**Project #20-054
In-N-Out Burger
Located at 404 North Main Street**

Project Name: In-N-Out Burger
Proponent / Owner: Cassie Yee (In-N-Out) / Logan Main and 4th Pads LLC
Project Address: 100 W 100 S
Request: Design Review Permit
Current Zoning: Town Center 1 (TC-1)
Type of Action: Quasi-Judicial
Date of Hearing: November 12, 2020
Submitted By: Russ Holley, Senior Planner

RECOMMENDATION

PRELIMINARY
PLAN

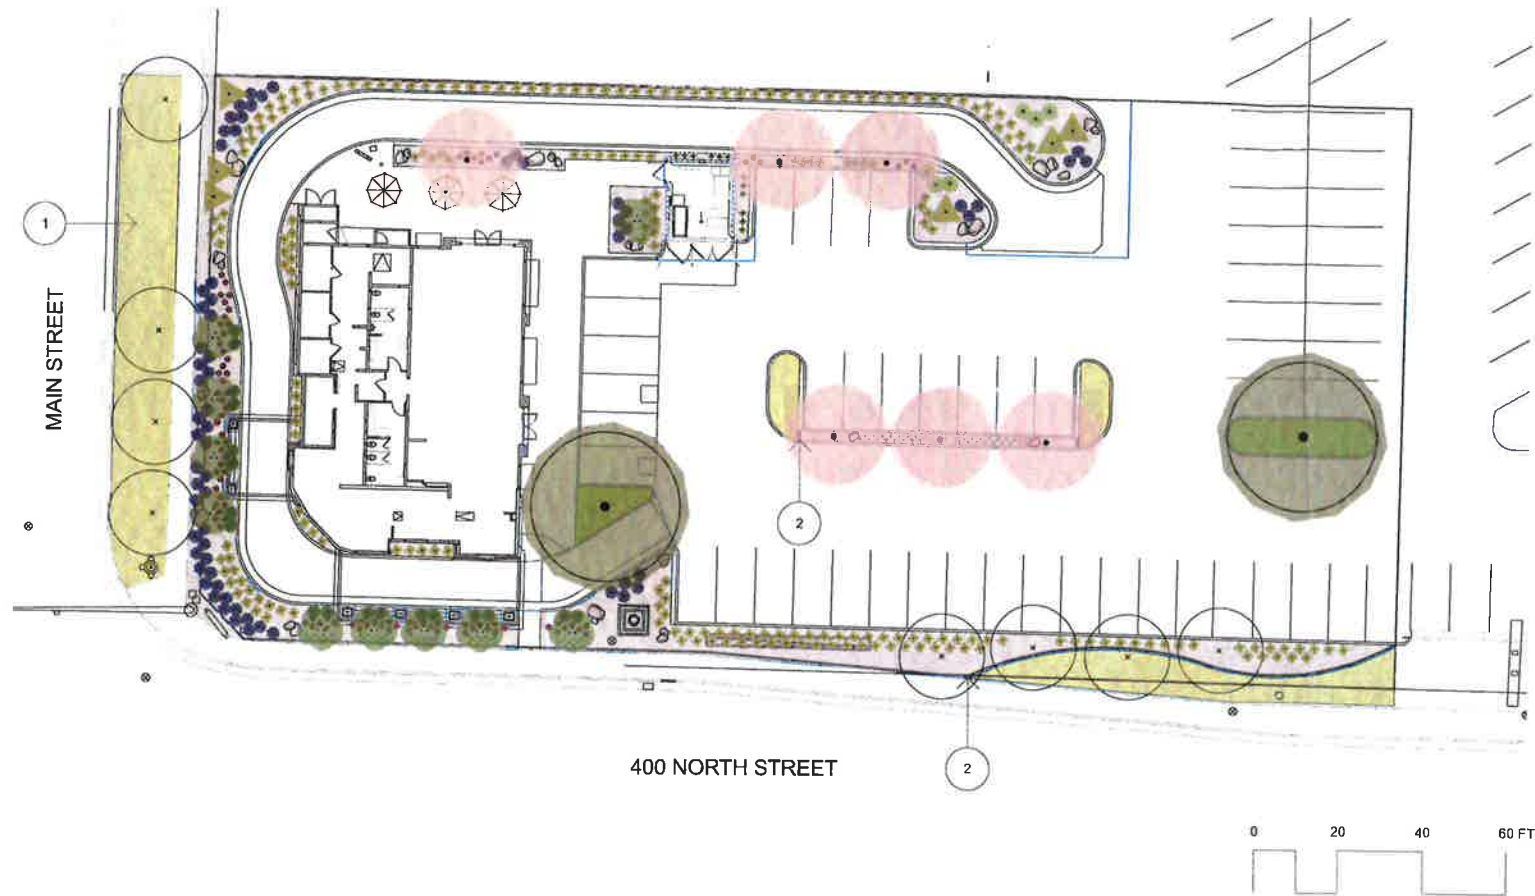
circulation and parking will occur east of the proposed building. The proposal shows new parking stalls at 90-degree angles with other existing areas of the block showing 45-degree angled parking. These two parking layouts are incompatible and pose vehicle circulation problems. Pedestrian circulation is required for commercial projects by code and is provided via the sidewalks along Main Street, 400 North and a new connecting sidewalk to the primary entrance across the drive-thru lane along the south façade. As conditioned with cross-access and consistent parking angles for adjacent parking stalls and drive isles, the project meets access and circulation requirements.

- 8) The project shall provide 33 parking stalls and a bike rack. All adjacent or opposite parking stalls shall either be 90 degree (perpendicular) or angled. Changes in direction shall only be made in separated areas of the parking lot.

EXTERIOR
ELEVATIONS

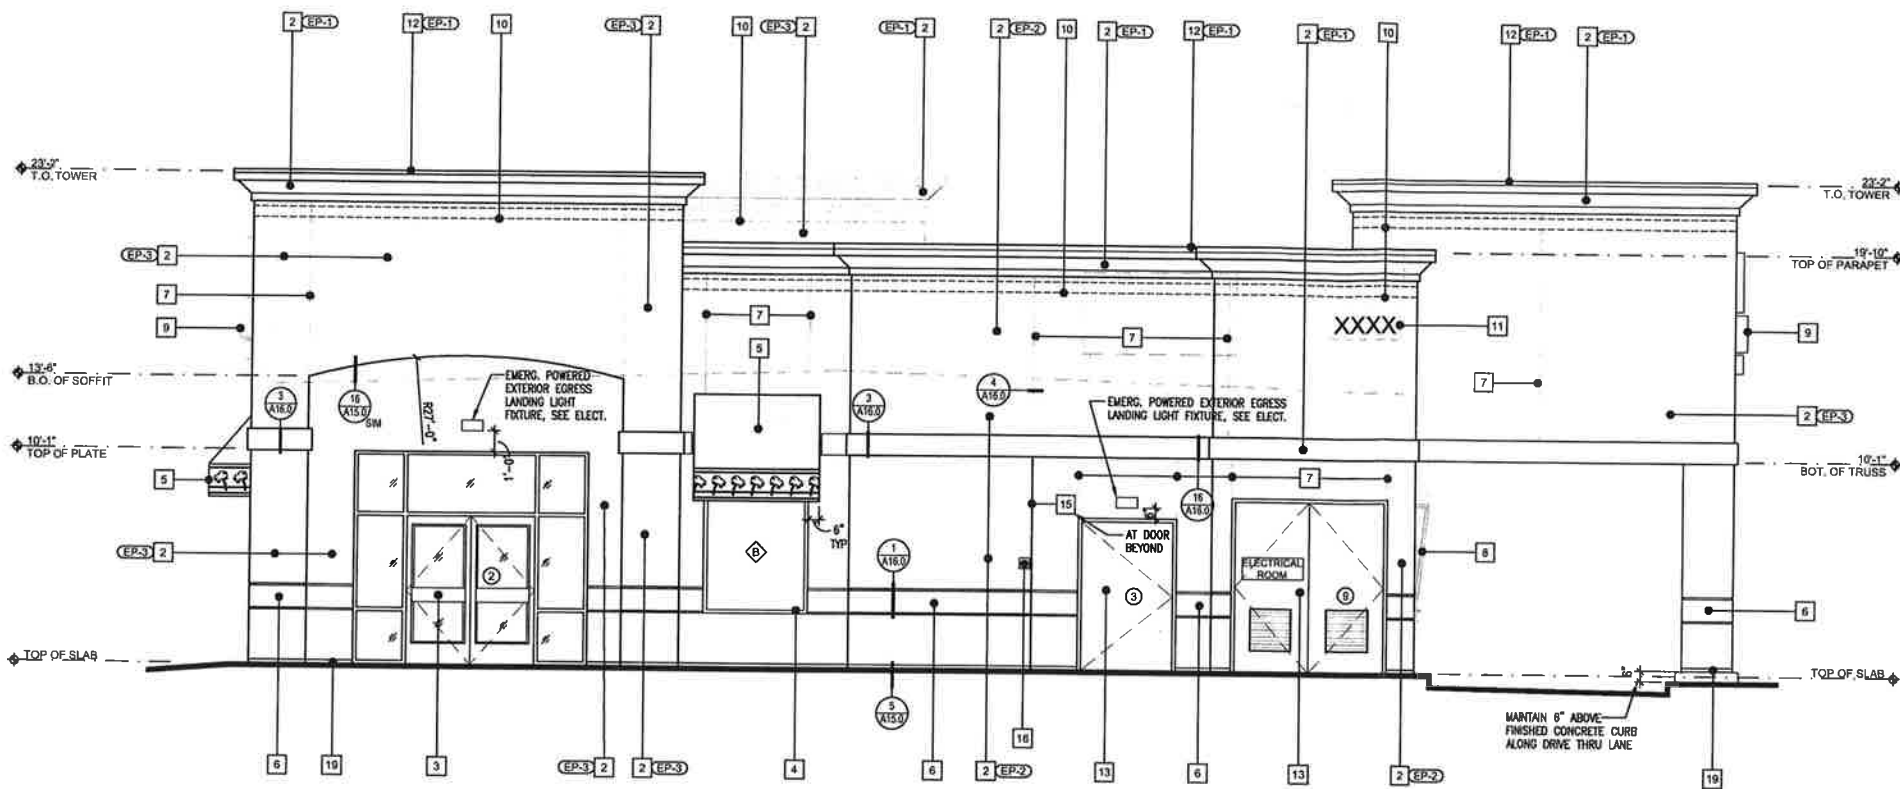
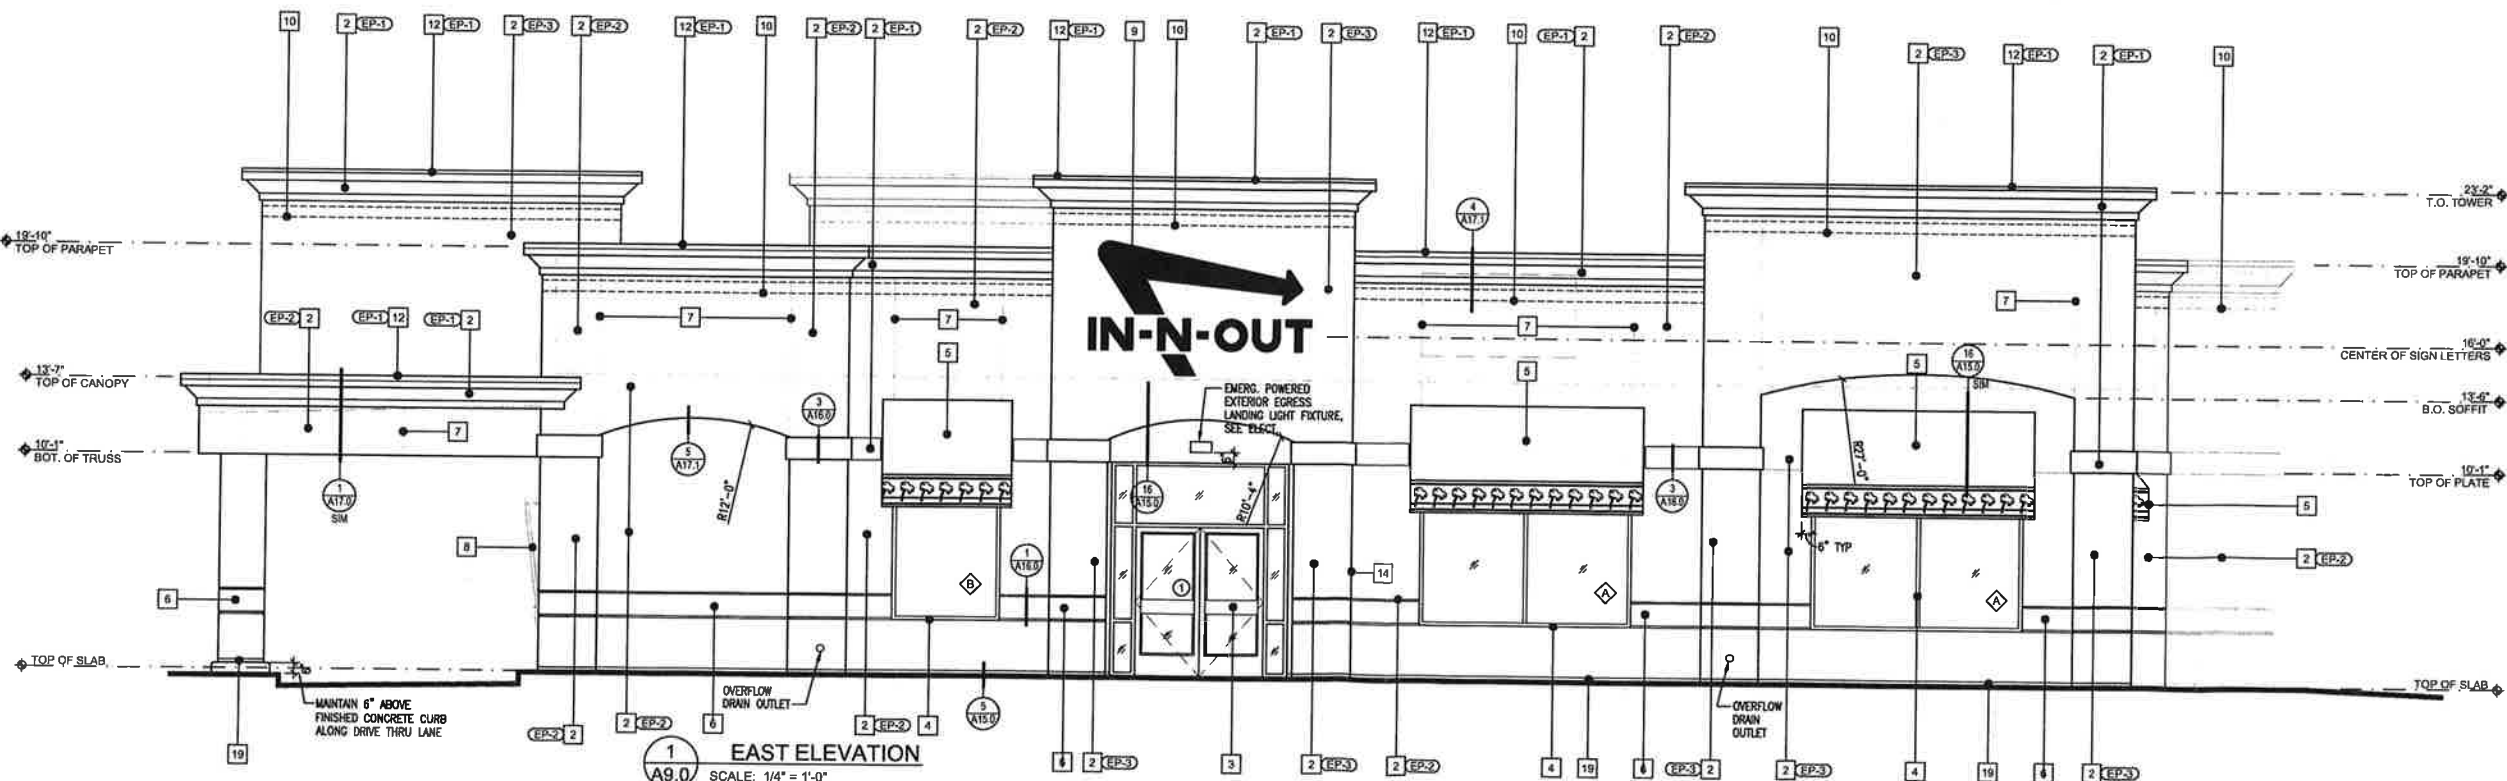
Transparency requirements for the TC-1 zone require ground floor frontage (street facing) commercial space to contain 60% transparency (fenestration). For this project site, the west and south façades are considered street facing frontages. The proposal shows a group of windows on the south elevation and a window on the west elevation. These façades also contain a series of columns forming a portico. The south side portico is shown with three columns and four

openings and the west side portico is shown with two columns and one opening. If counted towards transparency, the openings on the south side total 300 SF and the opening on the west side total 100 SF. Considering building width and a 12 foot ground-floor code height, the south side would require 400 SF of transparency and the west side would require 500 SF of transparency (60% of ground floor wall area). As conditioned with additional transparency, the project meets the LDC requirements.

The LDC 17.12.030 states that building's and primary entrances should be oriented towards the street. In situations where the primary entrance is not oriented towards the street, the street facing façade shall have similar façade treatments/details/style found on the façade containing the primary entrance. The proposal shows the building location near the intersection in a prominent position emphasizing architecture over asphalt along street frontages. This position helps to frame one of the busiest intersections in the valley with architecture. The orientation and primary entrance are shown towards the east (parking lot). This façade contains windows, awnings, entryways and roof variations. For code compliance, similar features should be found on the west/south façade. As conditioned with similar architectural features found on both the primary entrance facade and the street façade, the project meets the LDC requirements.

- 3) The porticos can be considered as meeting the intent of transparency in this application and setting.
- 4) An additional secondary building material shall be added to achieve a mix of materials.

- 5) The west façade shall be similar in architectural details as the east façade with the primary entrance and include the parapet/roof treatment over the 4-column portico.
